CASCADE APARTMENTS

Design Recommendation Meeting

DPD #3018928 - BUILDING A WEST

JANUARY 20, 2016

REVISED PARK FACING FACADE

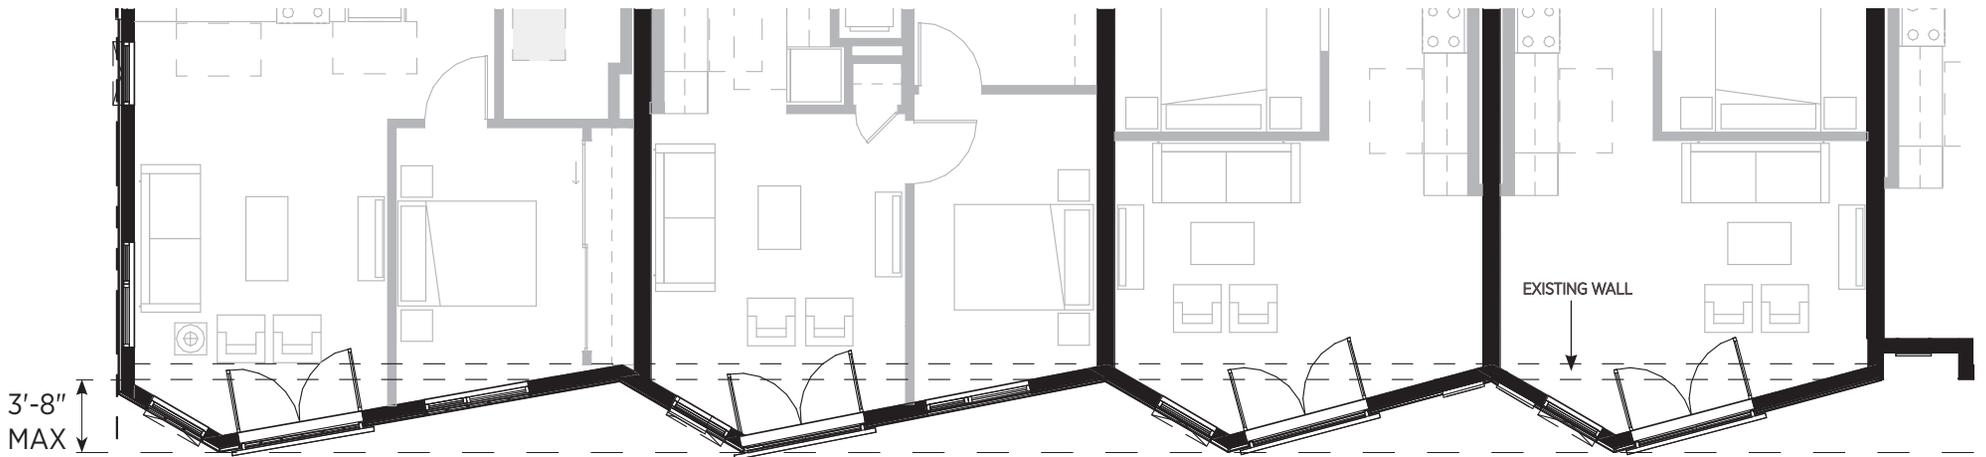
The Board observed that the upper level facades lack sufficient articulation or modulation, do not express a fine grain scale and window location/sizes do not emphasize the design concept. The plaid pattern is also not evident in the layering of color, depth, and facade texture.

The design should be modified for visual interest through both form and fenestration.

The Board noted that possible strategies to add depth and texture could include adding true balconies, adding modulation and articulation to emphasize the plaid concept, using fins around windows, and grouping and varying window sizes/proportions.

The Board clearly specified that the changes should include architectural moves at the upper facades, not only modifications to color or siding.

Our design response strengthens the design concept with the following changes:

Increase window size to emphasize and support plaid pattern. The taller windows now create diversity in the width of the horizontal banding, whereas before the horizontal bands were all the same. Both buildings typ.

Alternate direction of metal panel to create woven/layered texture, reinforce plaid pattern, add fine grain scale, and add surface complexity. Both buildings typ.

Redesign central massing elements to support plaid concept, while keeping focus on the main facade elements. Both buildings typ.

Flat panel added to reinforce pattern and provide diversity in texture and detail. Both buildings typ.

Windows and doors reorganized to emphasize facade pleating. Both buildings typ.

3'+ pleating modulation added to add substantial depth. Both buildings typ.

DRB RESPONSE STREET LEVEL - BUILDING B TERRACE

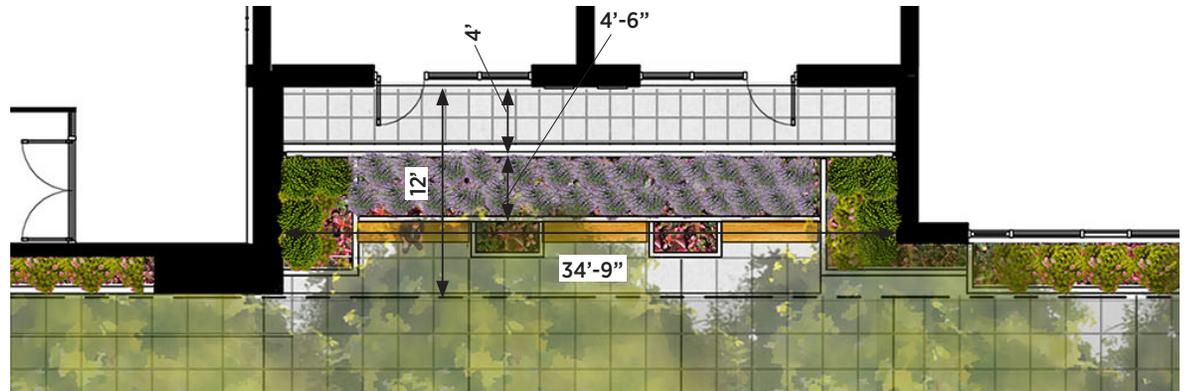
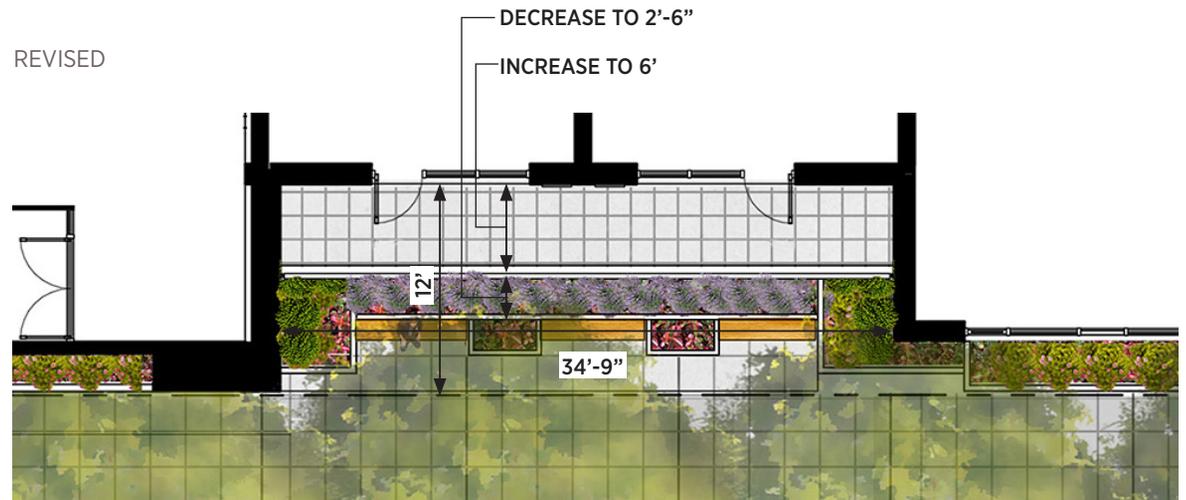
The Board directed the applicant to modify the depth of the terrace at the East building to 6' minimum depth to provide usable area. The Board noted that the depth of the landscaped setback could be reduced to achieve this depth. (PL1-A)

We have adopted the Board's direction to extend the terrace to 6'.

BUILDING A: GRADING PLAN AT ENTRY STAIR AND RAMP

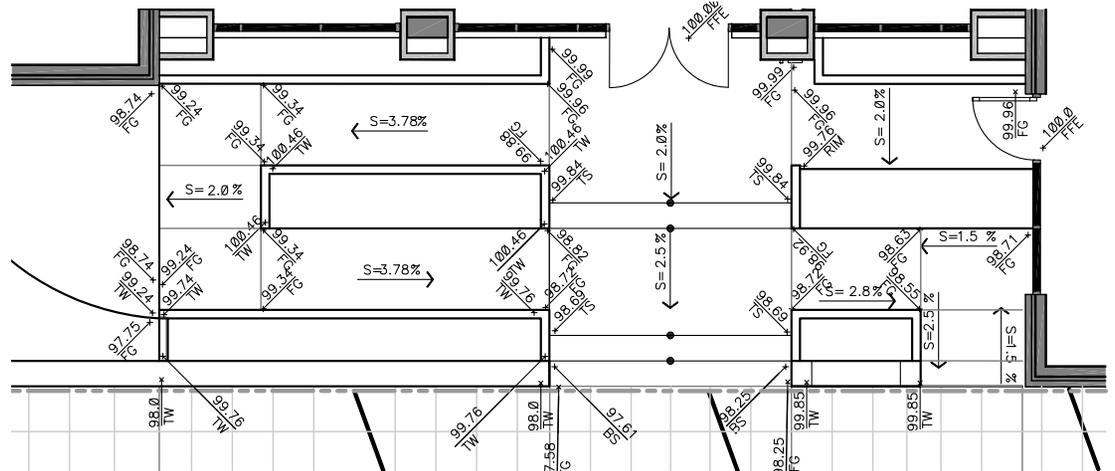
"The Board directed applicant to design the stairs at the entry to avoid handrails, thereby maintaining the proposed low appearance of ramps and stairs. (CS2-B, PL3-A)"

Confirmed, there will not be handrails at the entryway stairs in order to provide a welcoming transition from the street to the building entrance.

DRB RESPONSE ALLEY

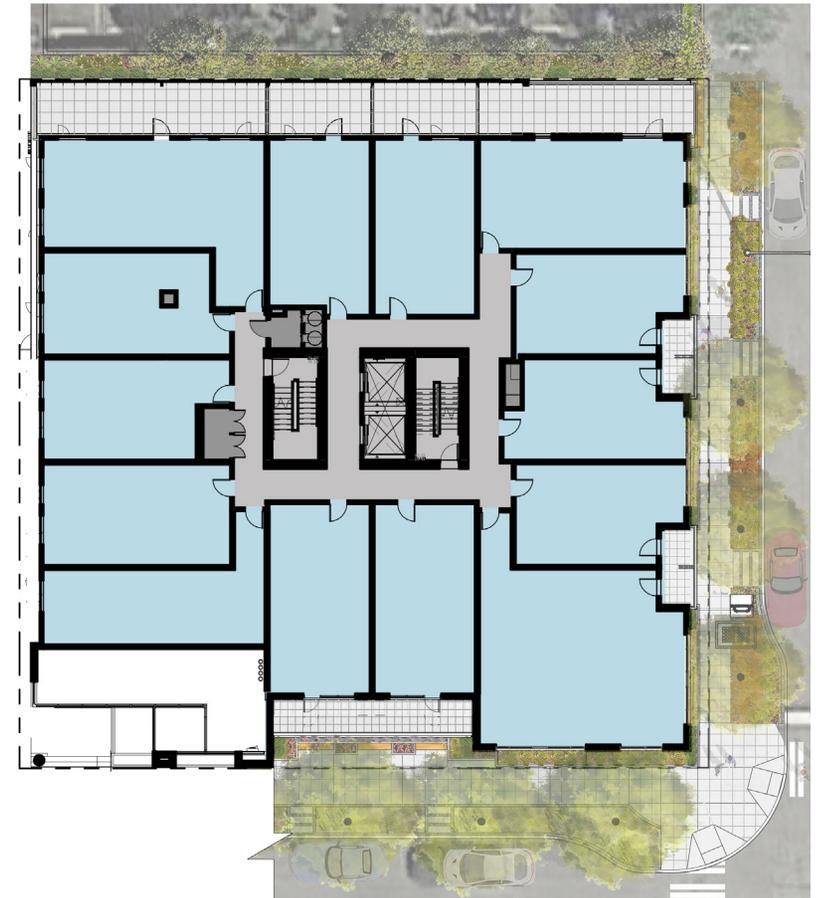
"The Board gave direction to include individual signage for ground level units at the alley and lighting at these units. (PL2-B, PL3-B, PL3-III)"

"The Board observed that the ground level alley units in the West Building are further below grade, and recommended that transom windows be added to increase natural lighting and visual height of these units. (PL3-III)"

In response to the Board we have added individual signage, additional lighting, transom windows, and windows raised to align with the top of the door transom. The material at the base of the building has been upgraded from fiber cement panel to metal panel.

Departure 2A - Upper Level Setback

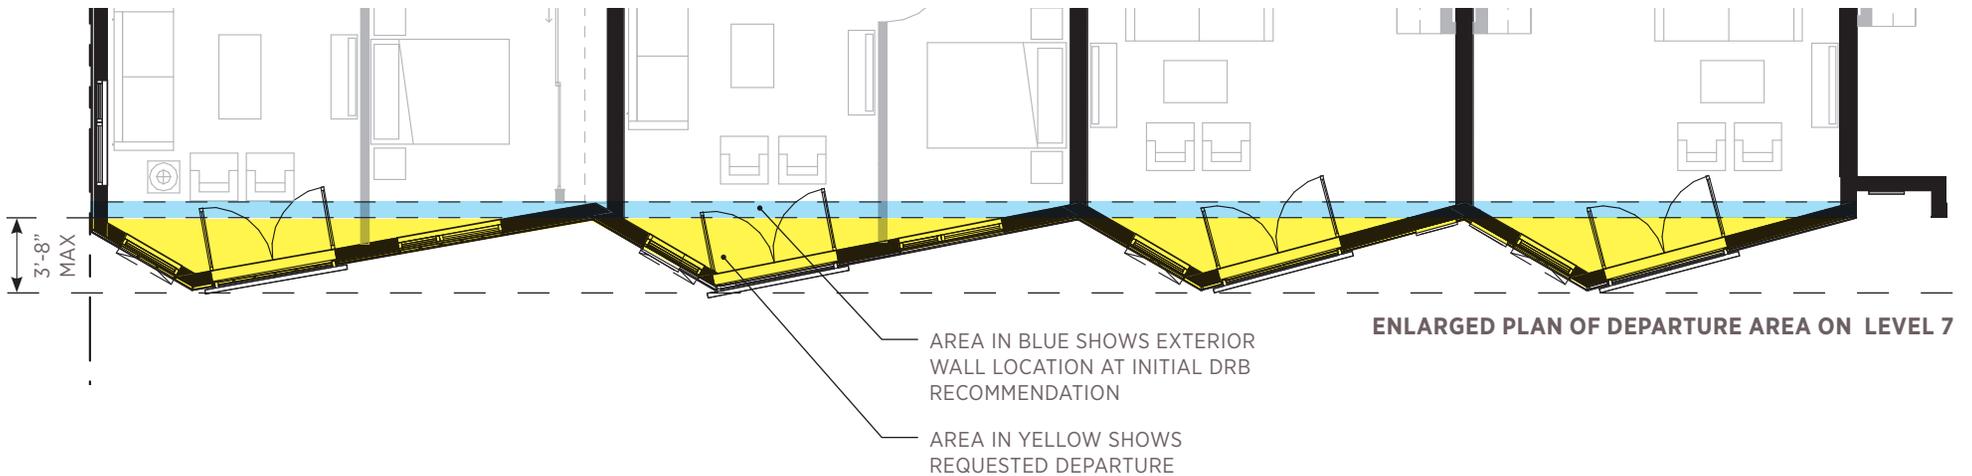
The departure is requested to provide additional modulation for the park-facing facade as requested by the Board.

We are requesting a departure for a portion of the South facade that projects into the required upper level setback. Area of requested departure shown in yellow above.

Departure 2B - Upper Level Setback

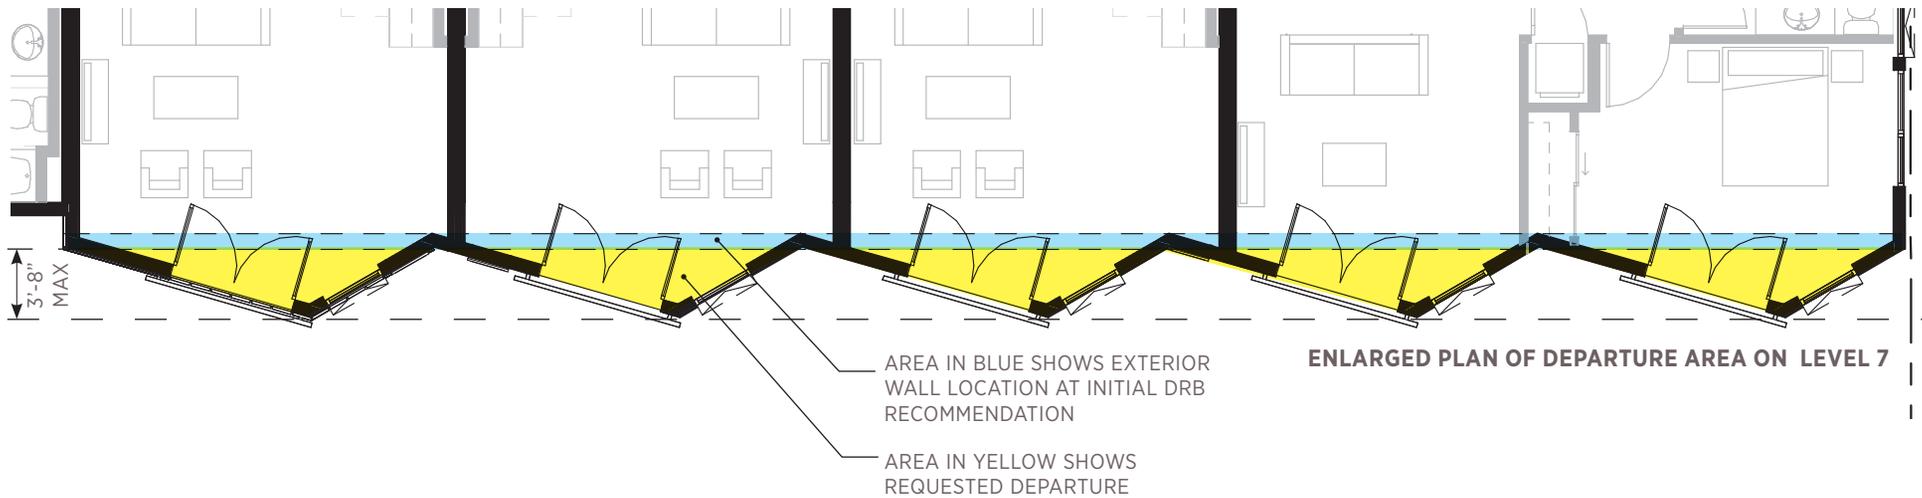
The departure is requested to provide additional modulation for the park-facing facade as requested by the Board.

We are requesting a departure for a portion of the South facade that projects into the required upper level setback. Area of requested departure shown in yellow above.
